Released for Permit
12/10/2020 9:53:53 AM
REGIONAL Building Department
daleh
MECHANICAL

RESIDENTIAL ADDITION for GUY & SUZANNAH MARTIN
16275 EAGLENEST DRIVE, COLORADO SPRINGS, CO. 80940

FIRST FLOOR PLAN 1/4" = 1'-0"

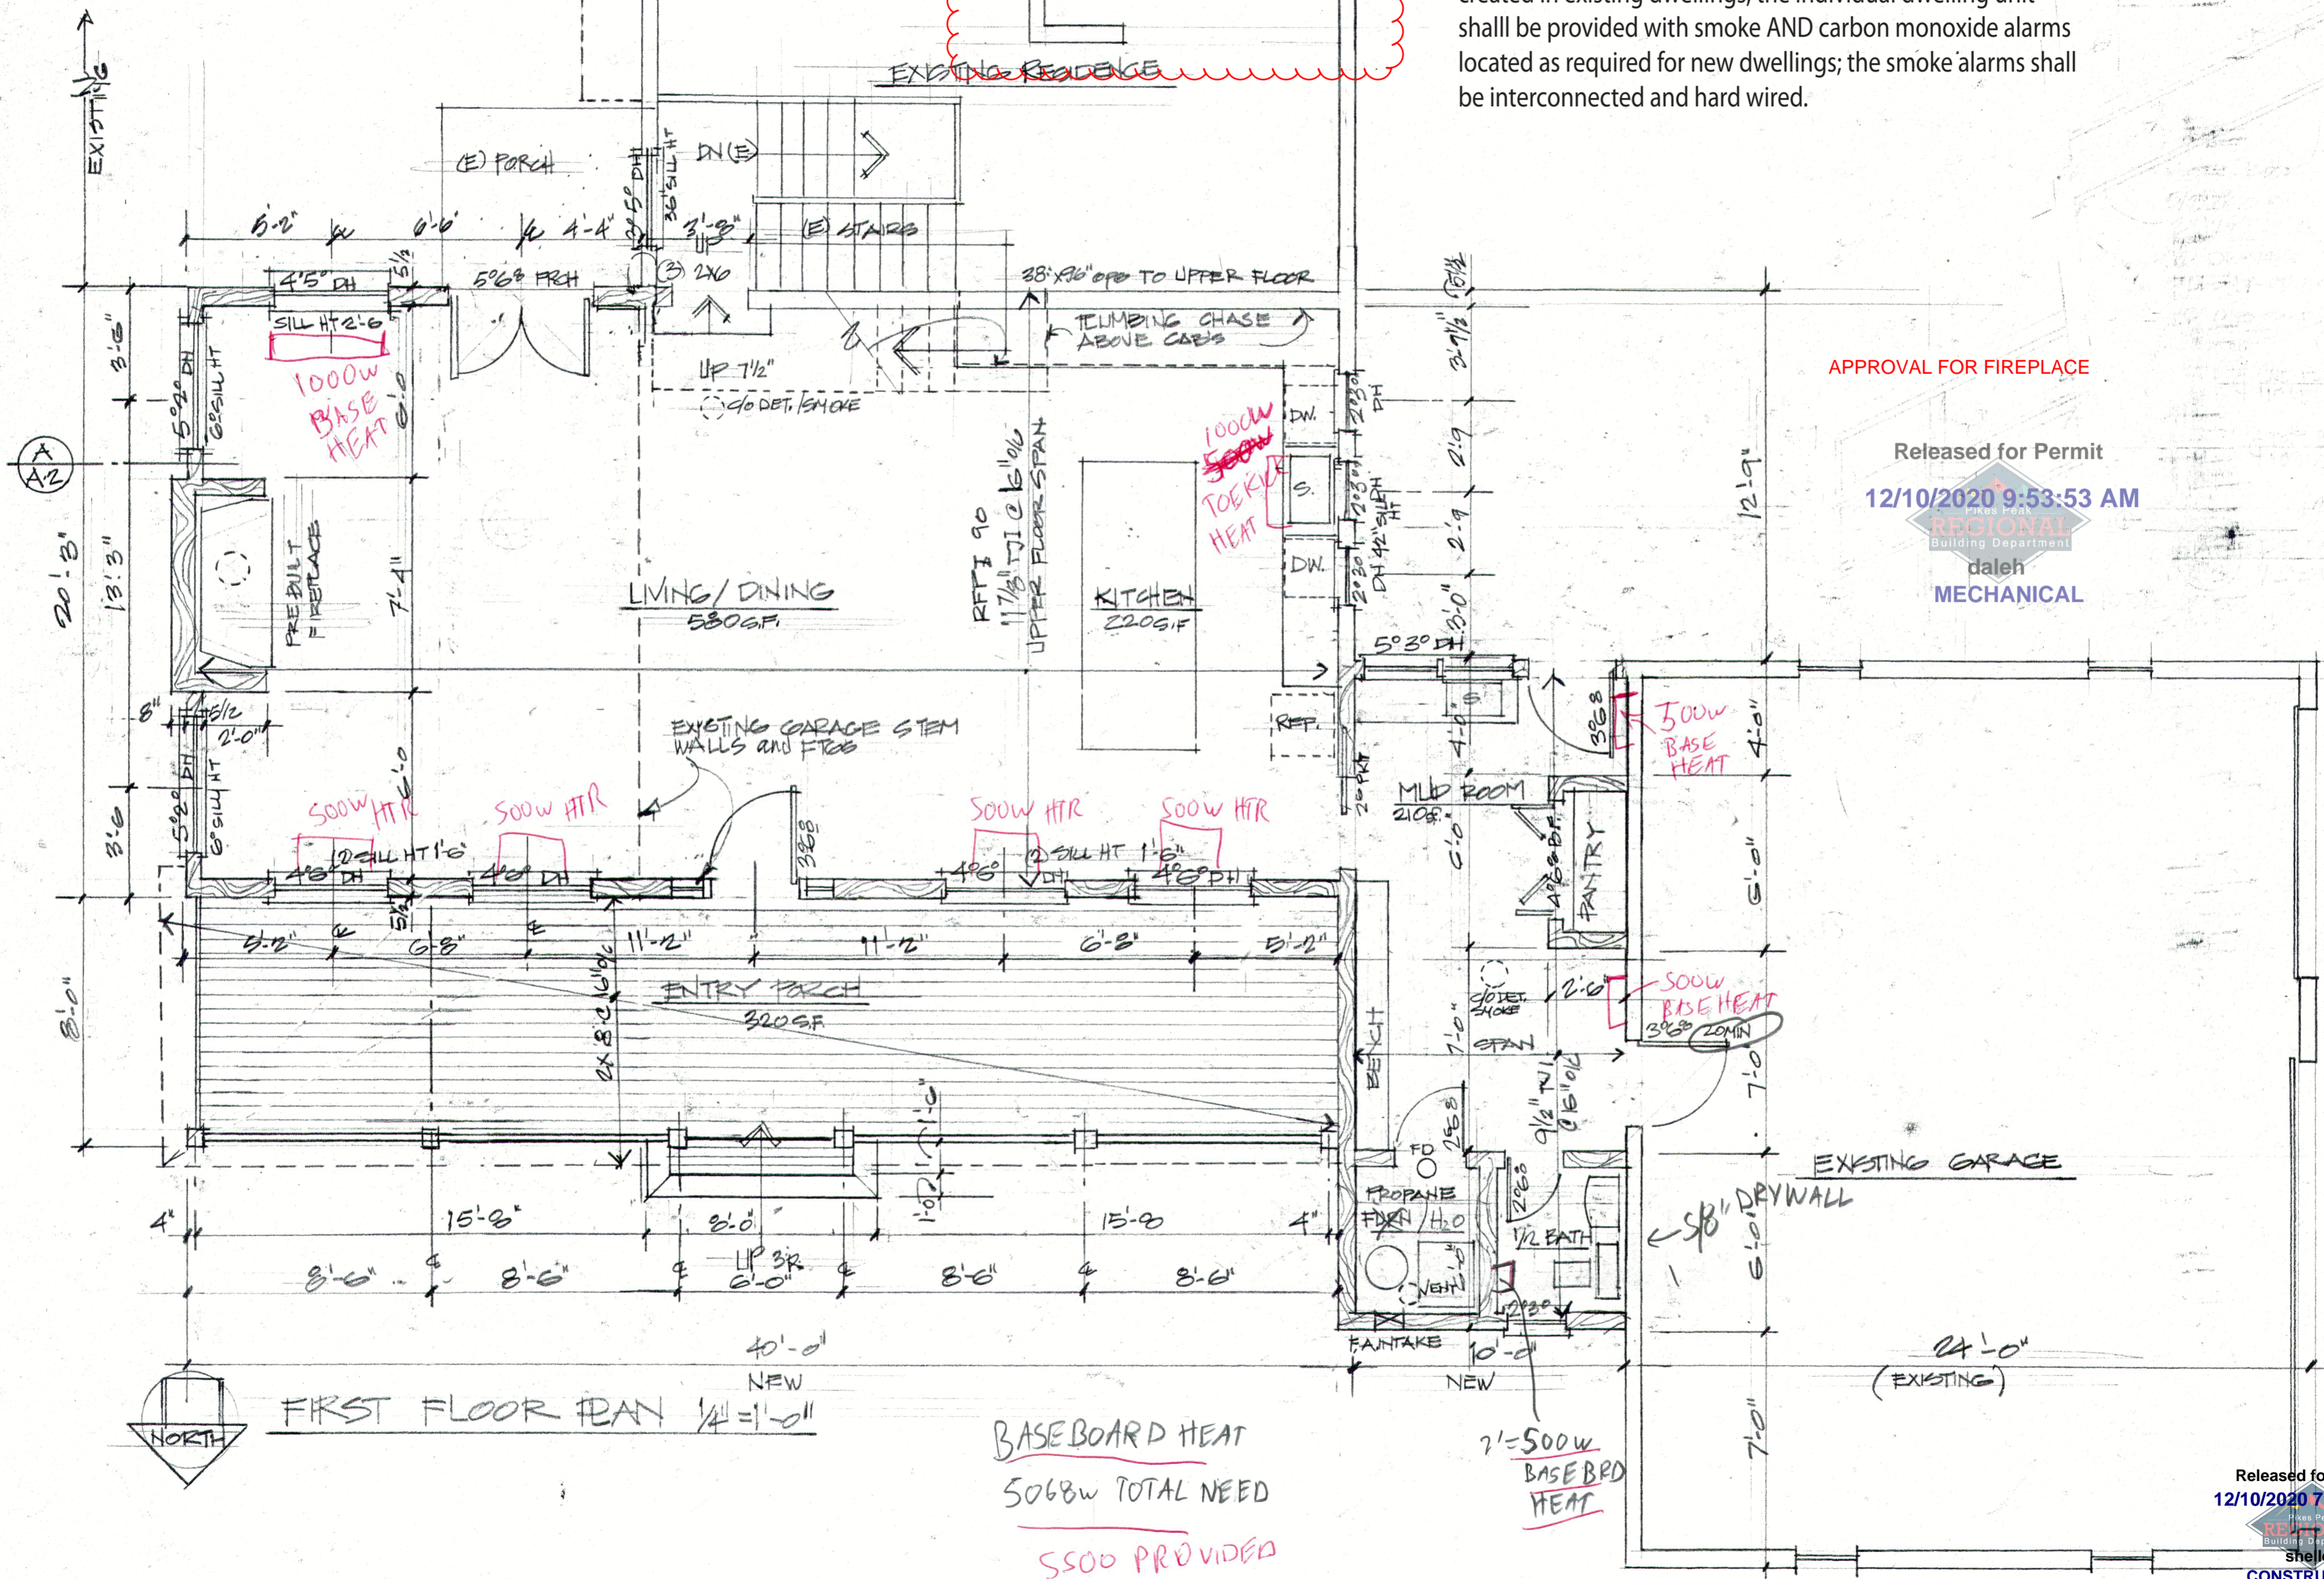
Existing kitchen to be converted to laundry room

[EB] R313.1.1 Alterations, repairs and additions. When interior alterations, repairs or additions requiring a permit occur, or when one or more sleeping rooms are added or created in existing dwellings, the individual dwelling unit shall be provided with smoke AND carbon monoxide alarms located as required for new dwellings; the smoke alarms shall be interconnected and hard wired.

APPROVAL FOR FIREPLACE
